SB, 1-15DS Lenze I550 VFD + Brake Resistor, 2024-02

Replacing the VFD from I510 to I550 with brake resistor solves this.

How to replace the I510 with an I550 + Brake Resistor.

Old, Eliminated 50Hz drive motor

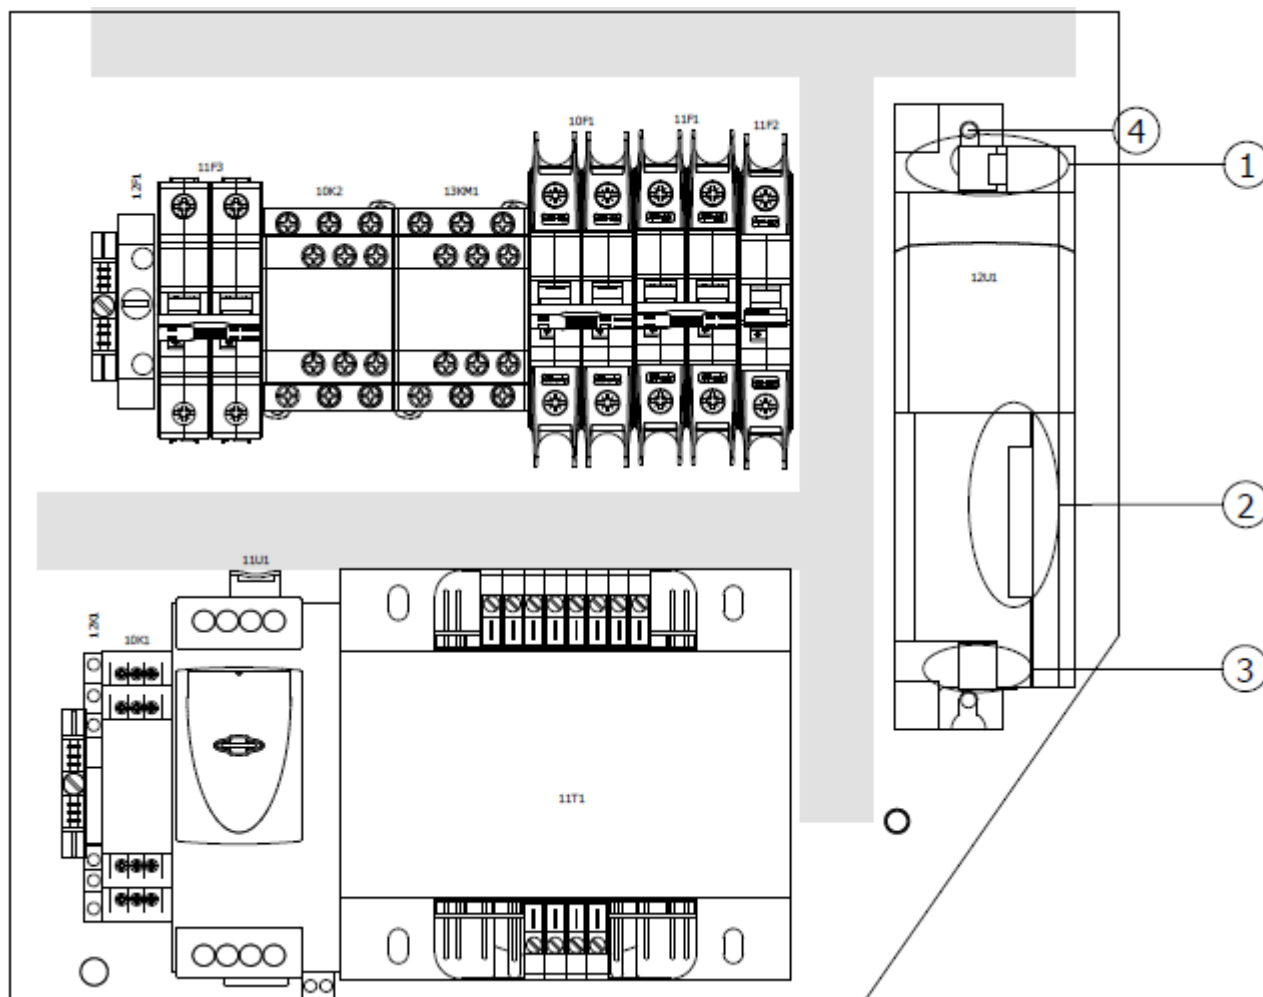
1. Check the serial number range in the table to see which part(s) you actually need to order.
2. Scrap parts in local stock? - *No*
3. The I510 is not eliminated, kept as *Orderable*.
4. 50Hz drive motor is eliminated, *Not able to order, replacement is 120Hz*.
5. Update products in local stock? – *No*
6. Recall products from customers and update? – *No*
7. Update sold products during next service only if part has caused a problem or anyway? – *No, replace only if I510 VFD fails or if the customer complains about the aforementioned symptoms.*

New, Active 120Hz drive motor

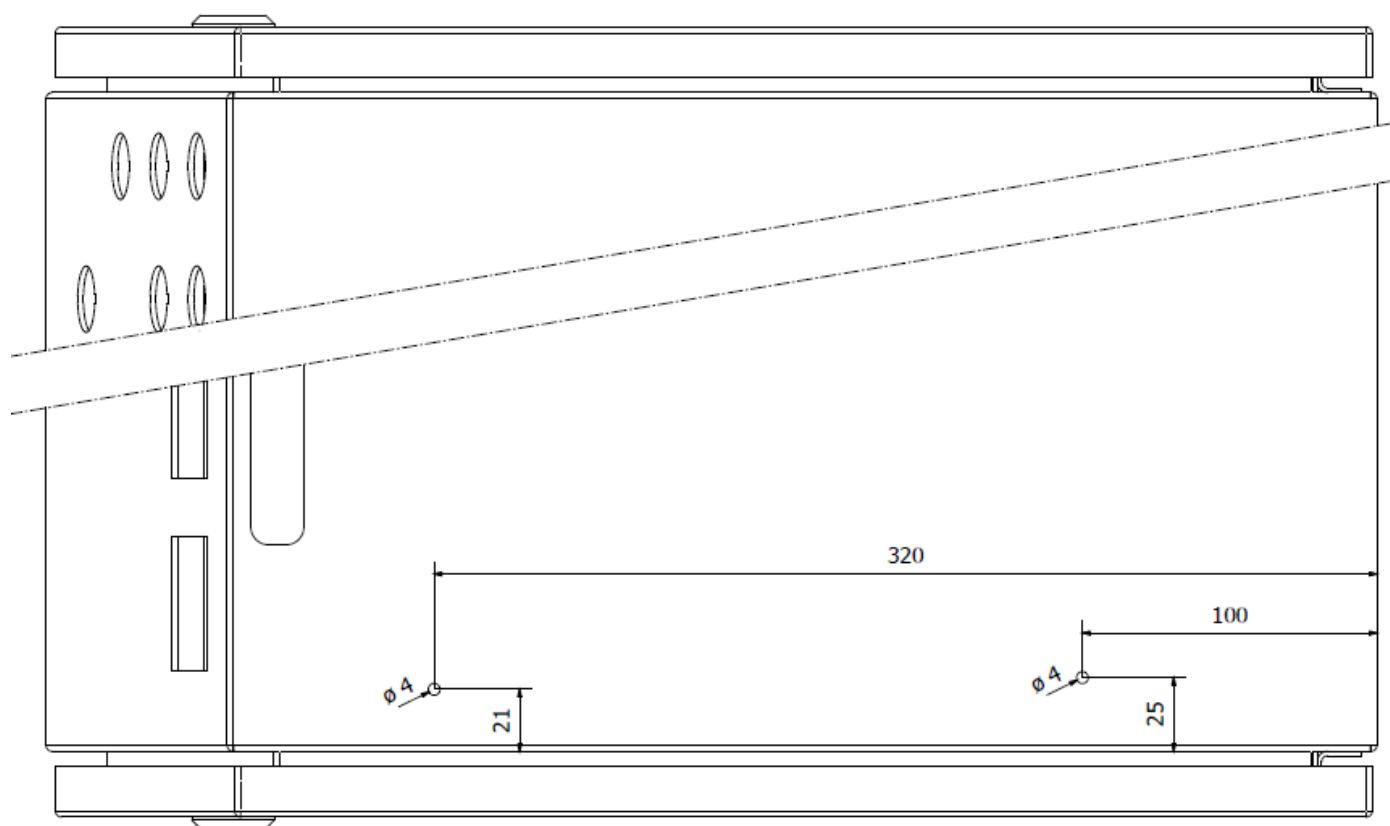
Drill 2 holes of 4mm according to the dimensions given here below for mounting the Brake resistor inside of the box.

1-15DS Dual Voltage - Overview E-Box, I510 without Brake Resistor.

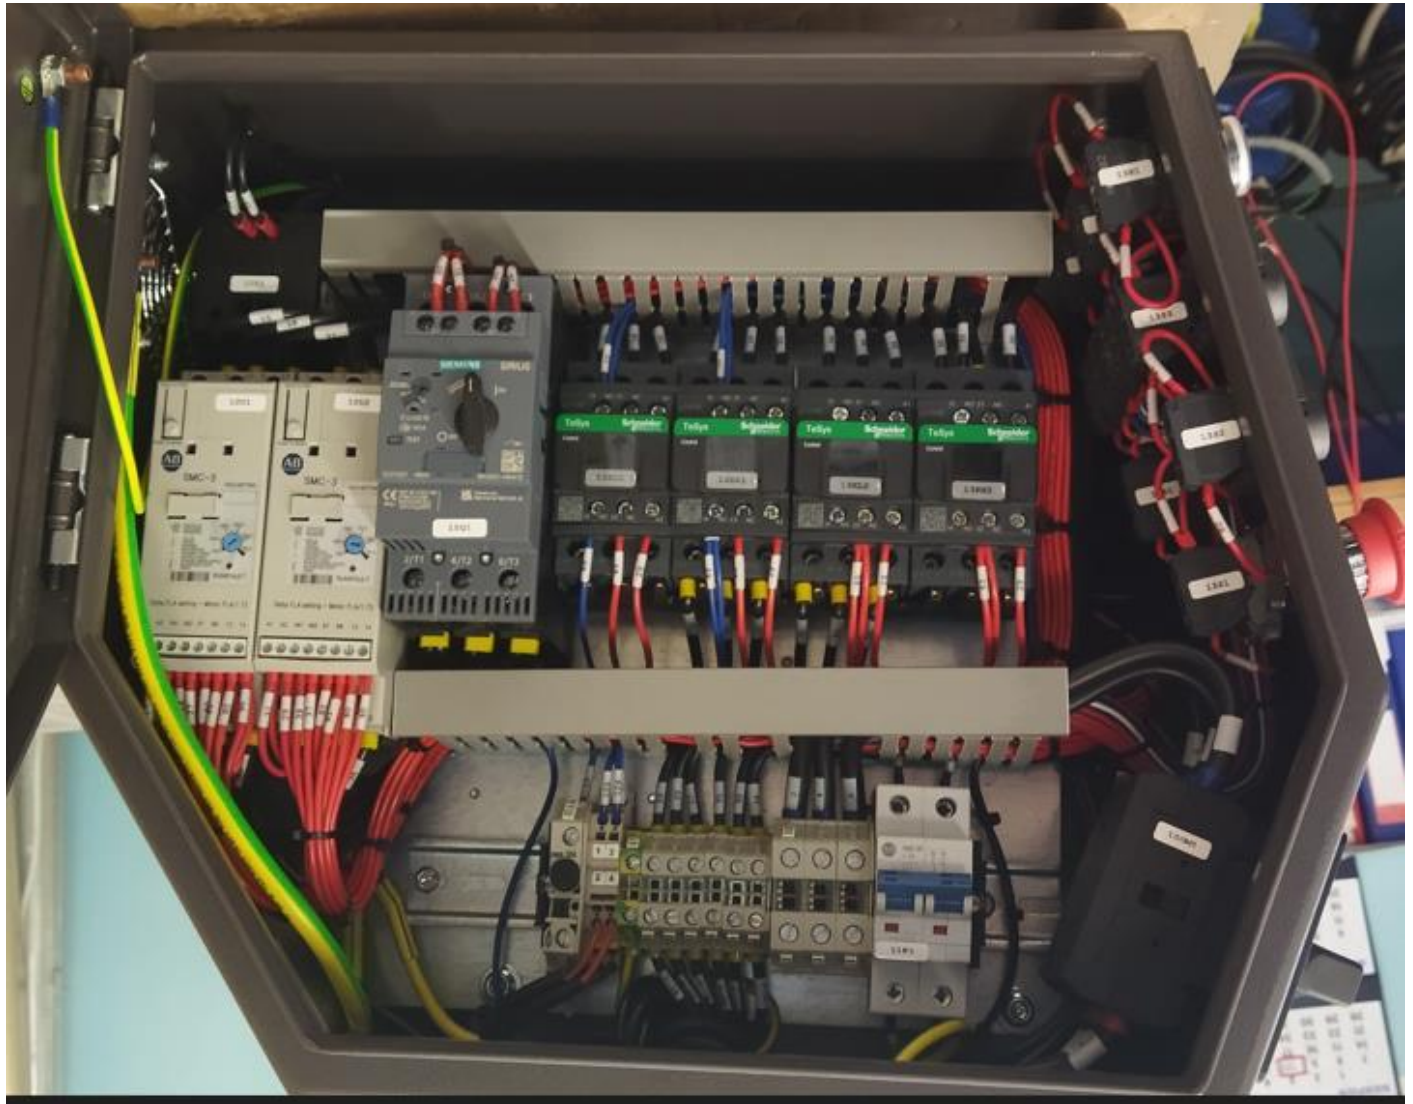
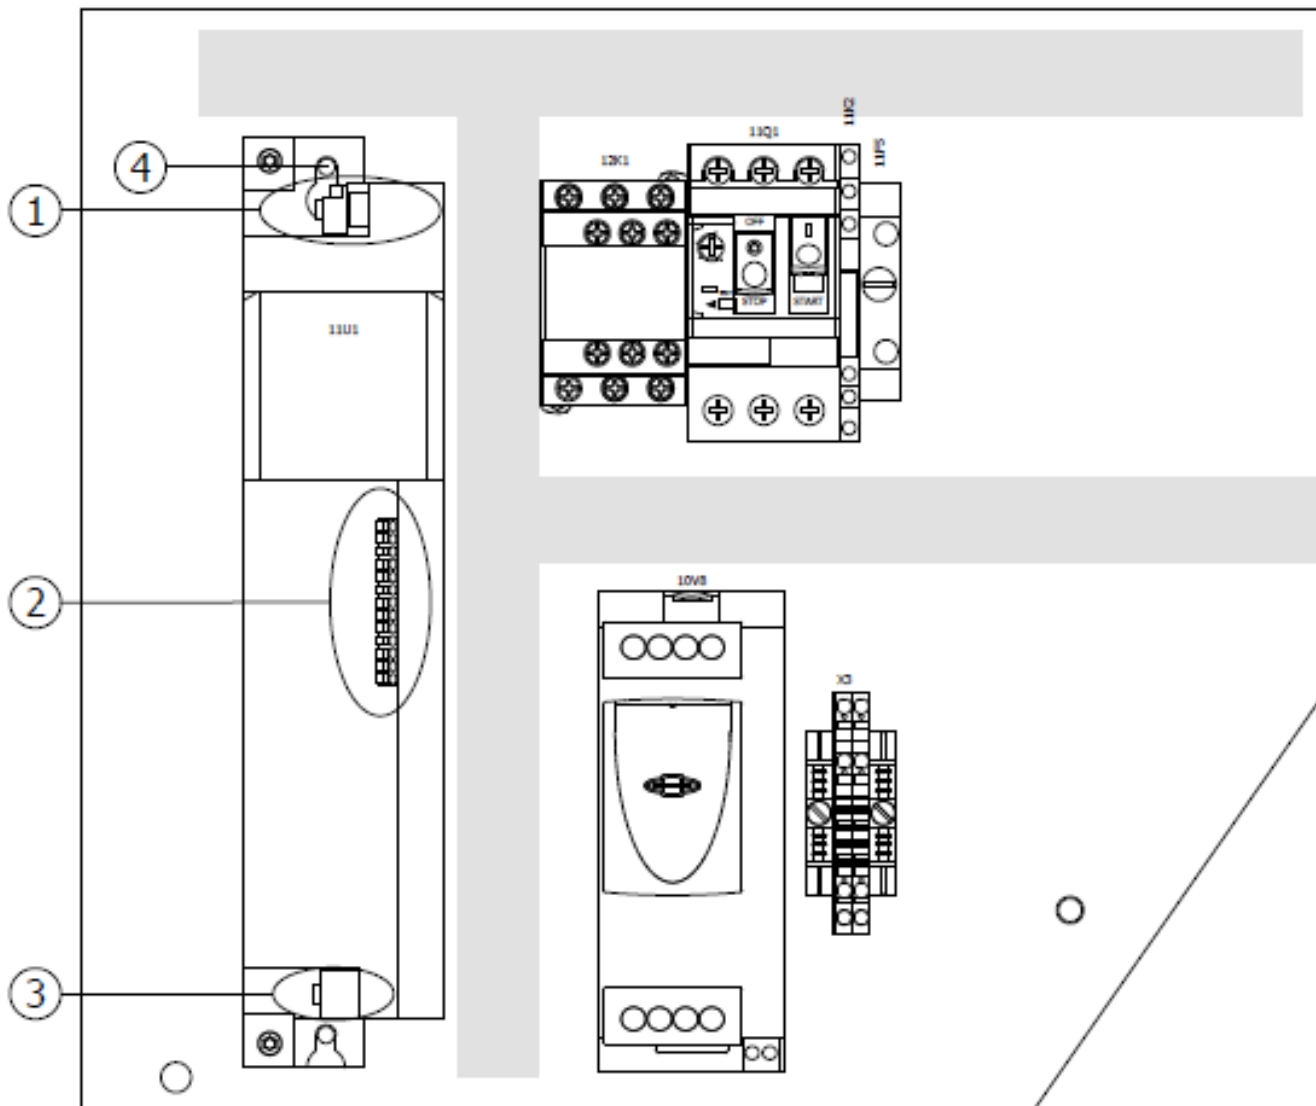
1-15DS Dual Voltage - Overview E-Box, I550 with Brake Resistor.

**Reconnecting the wires to the newly installed VFD and BR.
Refer to wiring diagram "PJ11.1065.REFIT" on page 11 and 11a.**

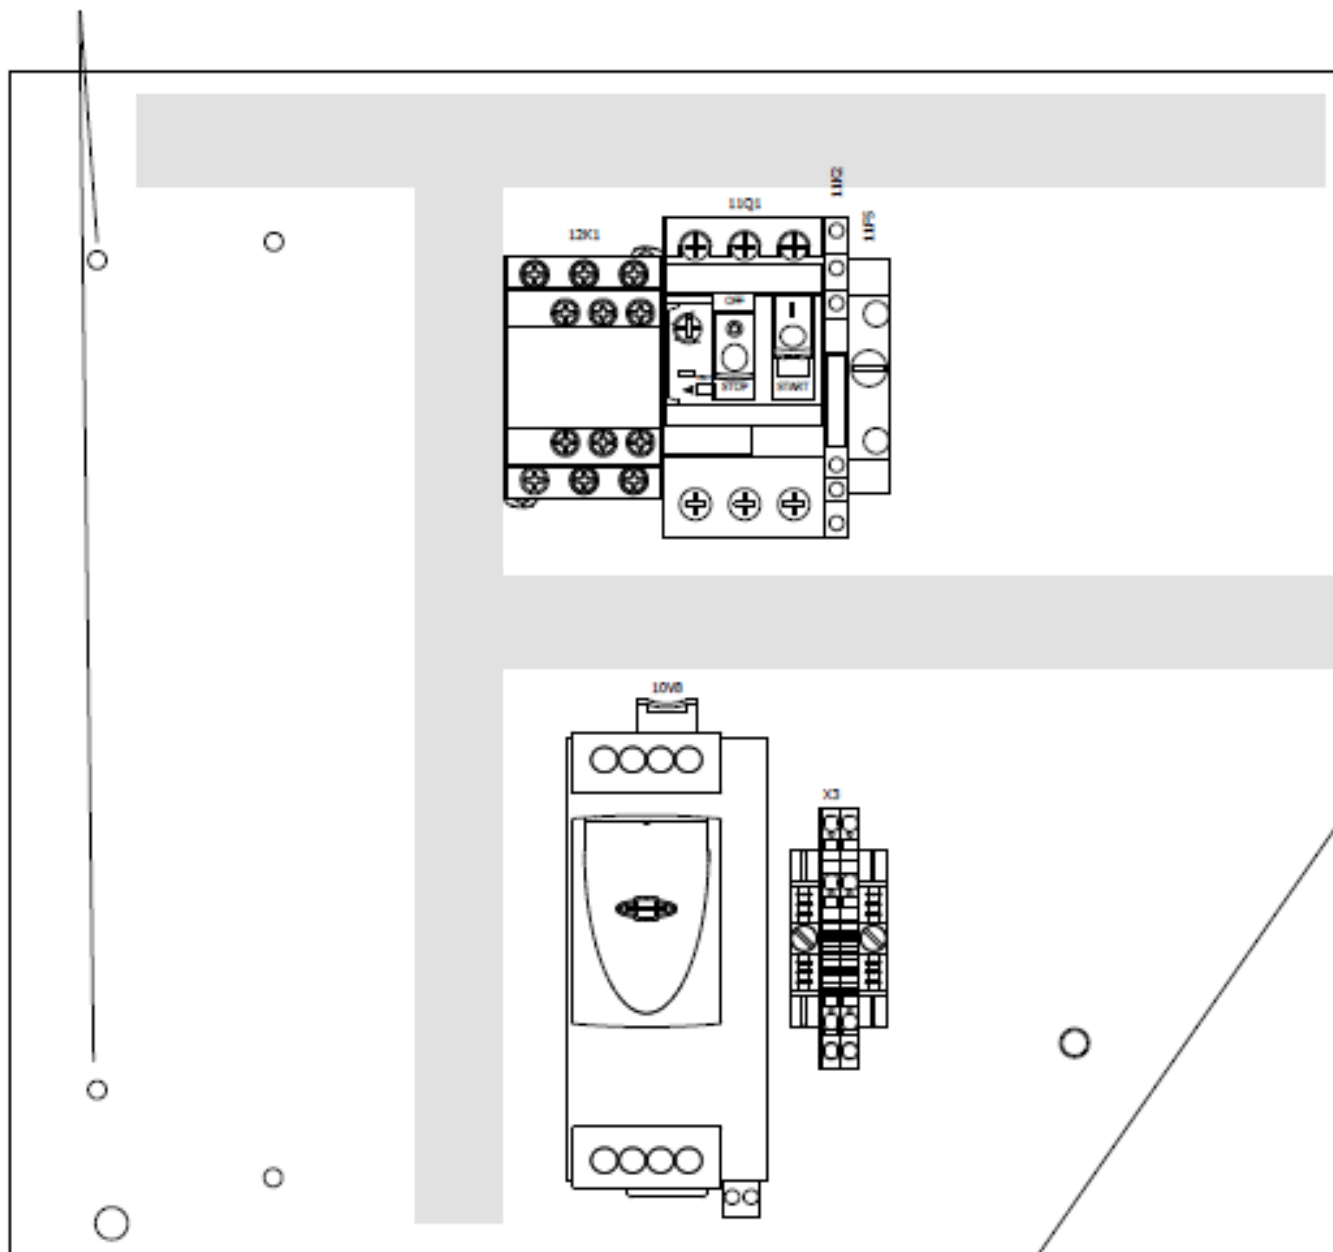
*** BE CAREFUL WITH DRILLING THE HOLES, THERE ARE OTHER PARTS MOUNTED ON THE BACKSIDE OF THE PANEL!**

Now you drill two holes of 4,2mm and then tap them with M5 thread.
